GSA-FSS
AMENDMENT-4
March 1, 1971
SUPERSEDING
Amendment-3
January 29, 1968

AMENDMENT

INTERIM FEDERAL SPECIFICATION

SHEARS AND SCISSORS

FIGURE 12A. Point configuration.

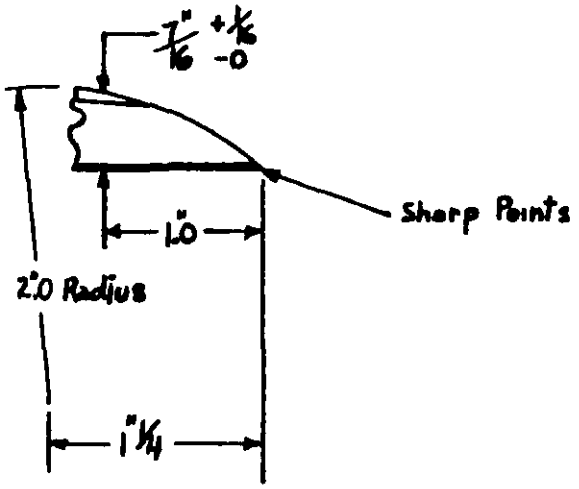
Paragraph 3.10.6, delete entire paragraph and substitute:

3.10.6 Type II, class 6, electricians. Class 6, electricians' scissors shall be designed with both blades pointed and shall have dulled, serrated scraping edges on backs of the blades. Class 6 scissors shall conform to table III and be similar to figures 12 and 12A.

FIGURE 13. Scissors testing machine.

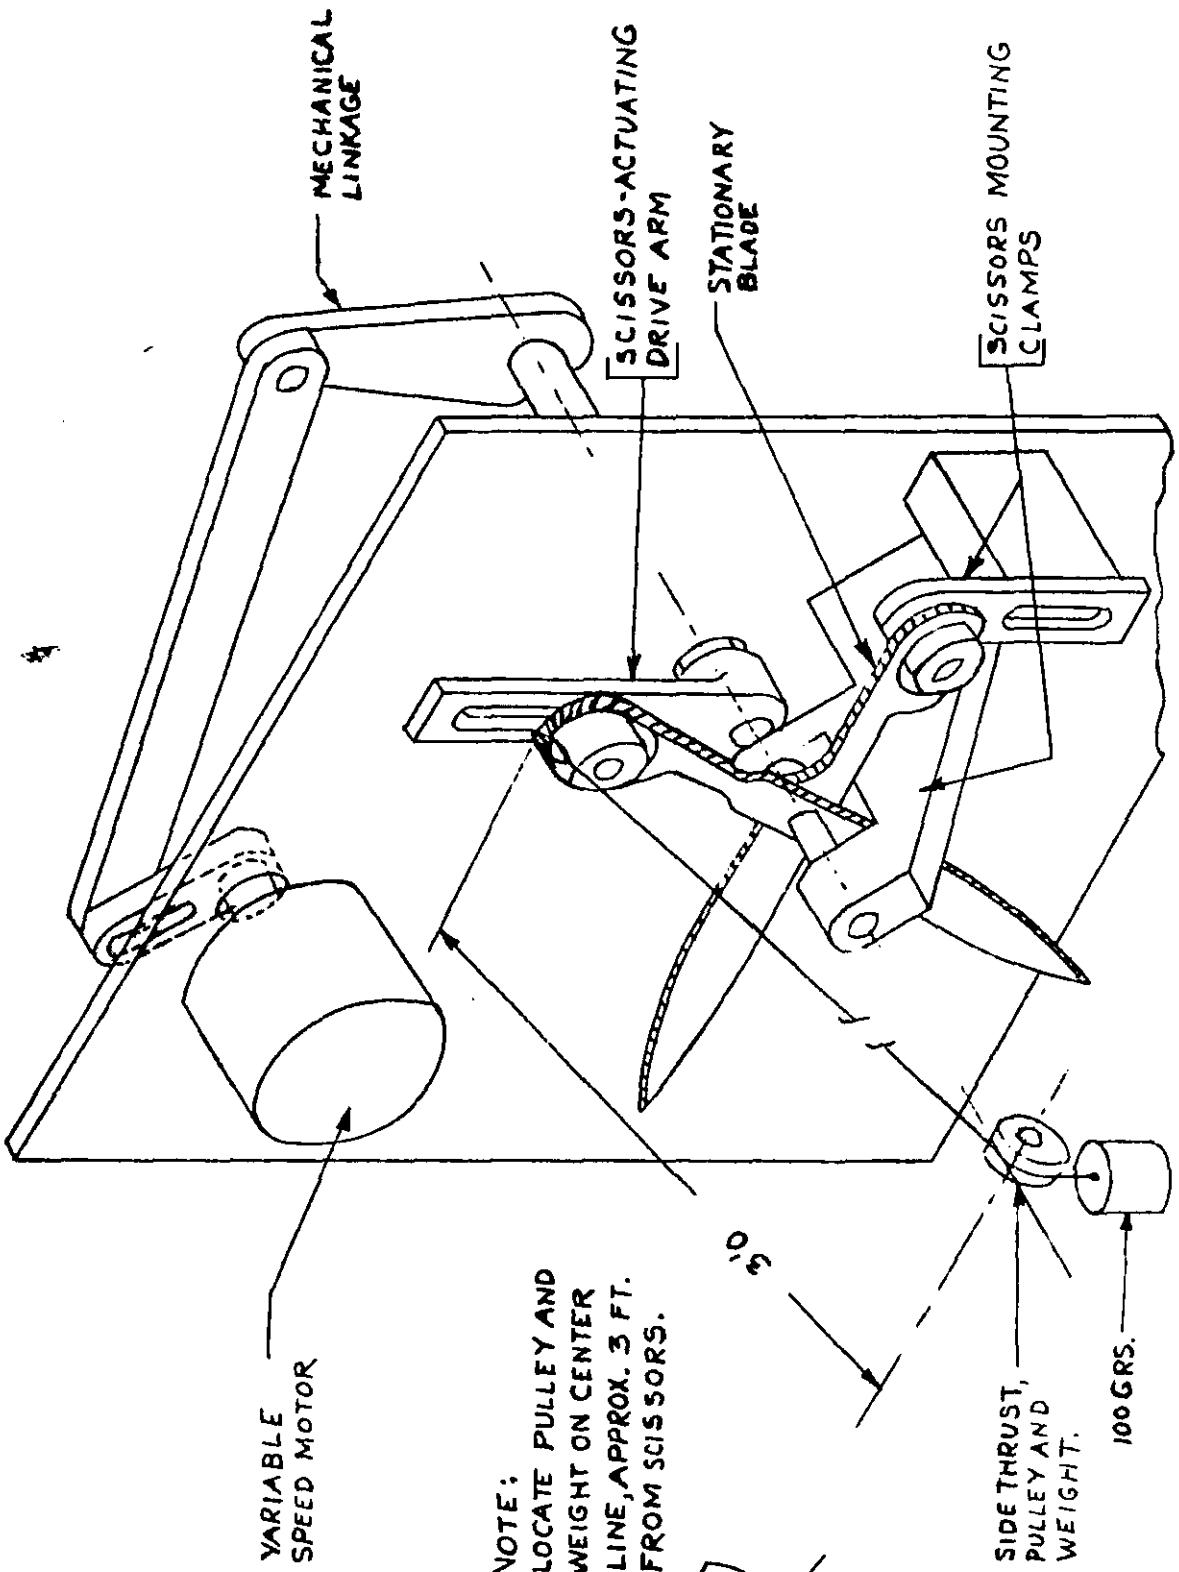
Delete paragraph 4.5.1.5 and substitute the following:

4.5.1.5.2 Aluminum oxide cutting test. Each sample scissors shall be required to make a total of 150 cuts in 150 grit aluminum oxide single-faced abrasive cloth. After every 25 cuts, the scissors shall be tested for cutting one thickness of 3.8 ounce cotton shooting (see 4.5.1.5.1). During the next 25 cuts, the opposite blade shall face the abrasive side of the aluminum oxide cloth. Failure to cut the 3.8 ounce cotton cloth cleanly for at least 3/4 of the length of the blade, measured from the tips, shall be cause for rejection. The tests requiring 25 cuts in the aluminum oxide described above shall be performed by hand; however, after every 25 cuts (by hand) the tests for cutting one thickness of 3.8 ounce cotton shooting (see 4.5.1.5.1) shall be performed on a testing machine like or similar to that shown in figure 13 and described in paragraph 4.5.1.5.2.1.

4.5.1.5.2.1 Scissors testing machine. The testing machine shall be designed to clamp the screw that joins the scissors between two pins, and retain one blade in the horizontal position by holding the thumb loop on a fixed mandrel. The finger loop of the other blade shall be positioned on a movable mandrel which shall be actuated by a variable speed motor through a mechanical linkage system. The speed of the motor shall produce 75 ± 10 percent cuts per minute. The mechanical linkage system shall force the movable blade fully open (not to exceed 90° included angle) and then fully close the scissors (so that points meet or overlap slightly) in each cutting cycle (see figure 13). A string or light cable shall be attached, as indicated in the figure, to the end of the finger loop of the movable blade, and a 100 gram weight shall be attached to the other end. The cable and weight shall be positioned over a pulley located three feet from, and on the center line of the screw that joins the scissors so that the 100 gram weight acts in the direction to pull the two blades together assimilating side thrust.
